**LEXINGTON-FAYETTE URBAN COUNTY  
GOVERNMENT CONTRACT CHANGE ORDER**

Date:	March 10, 2015
Project:	Senior Citizen Center Construction
Location:	Lexington
Contract No.	227-2014
Original Contract Amt.	\$8,882,900.00
Cumulative Amount of Previous Change Orders	\$180,584.31
Percent Change - Previous Change Orders	2.03%
Total Contract Amount Prior to this Change Order	\$9,063,484.31
Change Order No.	11

PROJECT: Senior Citizen Center Construction

CHANGE ORDER: 11

**Figure 1: Photo of Excavations**

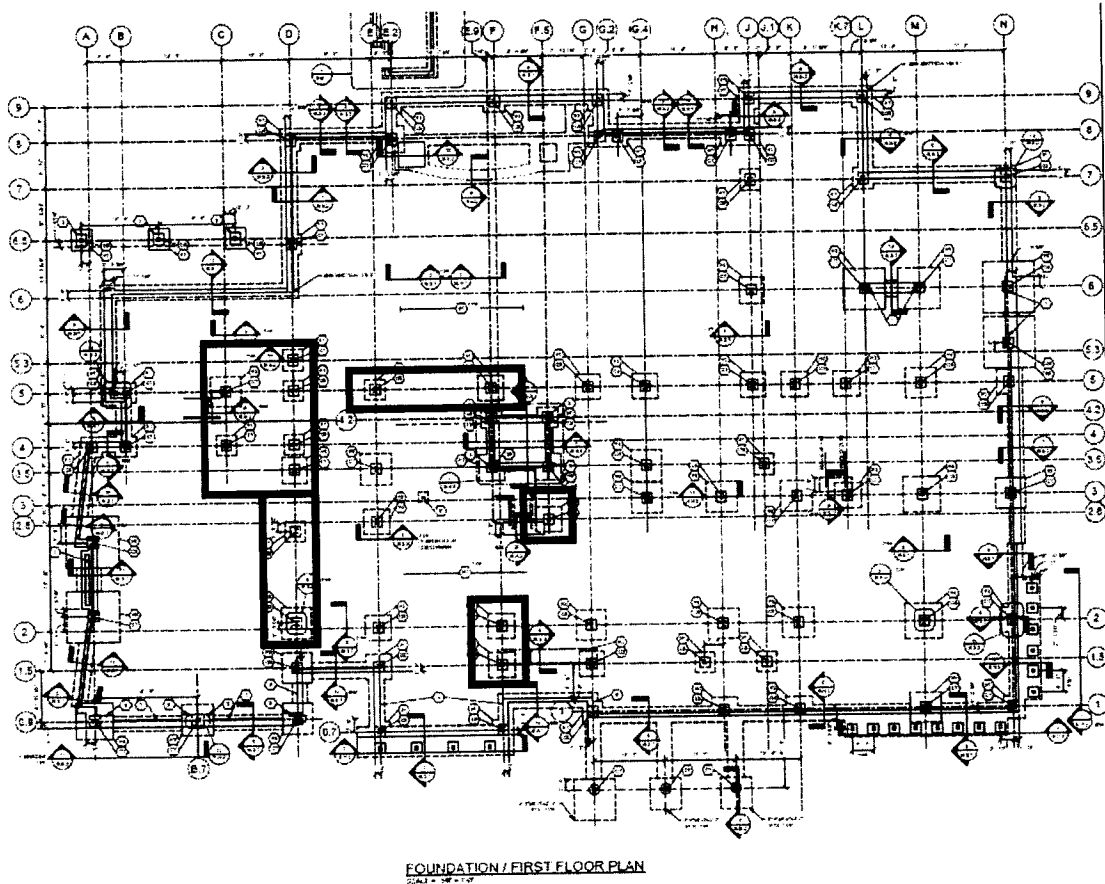
The writer observed the contractor excavate column footings at Column Lines C / 4 & 5, D / 2 – 5.3, E / 5, E.9 / 5, F / 1.5 & 2, and F.5 / 2.8. The footing excavations exposed tan to brown, saturated, soft, silty clay with topsoil. The exposed surface did not appear to be suitable for the design bearing capacity of 3,000 pounds per square foot. The writer observed the contractor undercut the areas to 24" below bearing elevation. The extra excavation exposed brown to dark brown, moist, soft, topsoil with organics. This surface appeared suitable for a bearing capacity of approximately 1,000 pounds per square foot, or less than the design bearing capacity. The areas were then undercut as follows:

Column Line	Undercut Depth (feet below bearing elevation)
C / 4	4
C / 5	6
D / 2.8	4
D / 2	5
D / 3.5	5
D / 4	4
D / 5	4

D / 5.3	4
E / 5	5
E.9 / 5	5
F / 1.5	5
F / 2	5
F.5 / 2.8	5

The undercut volume was calculated to be 54 cubic yards. The writer observed the contractor place 63 cubic yards of flowable fill in the excavations to bring them back to original bearing elevation.
